# ARKANSAS NUCLEAR ONE - UNIT 1

## IMPROVED TECHNICAL SPECIFICATIONS SUBMITTAL

January 28, 2000

<u>NUREG-1430</u>	<u>ANO-1 ITS</u>	<u>Title</u>
3.3.11	3.3.11	Emergency Feedwater Initiation and Control (EFIC) System Instrumentation
3.3.12	3.3.12	Emergency Feedwater Initiation and Control (EFIC) Manual Initiation
3.3.13	3.3.13	Emergency Feedwater Initiation and Control (EFIC) Logic
3.3.14	3.3.14	Emergency Feedwater Initiation and Control (EFIC) - Emergency Feedwater (EFW) - Vector Valve Logic

Table 3.3.11-1

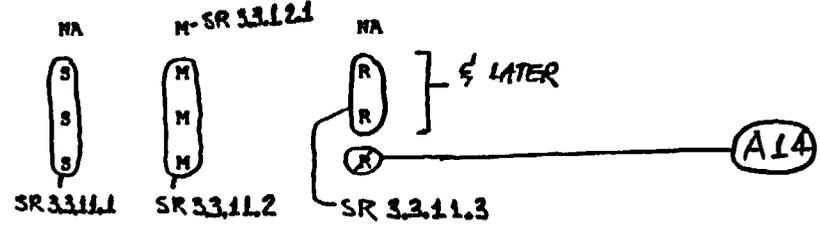
- a. Manual
- # 1.b b. SG Low Level, SGA or B
- # 1.C c. Low Pressure SGA or B
- # 1. d. Loss of both MFW Pumps and PWR > 100
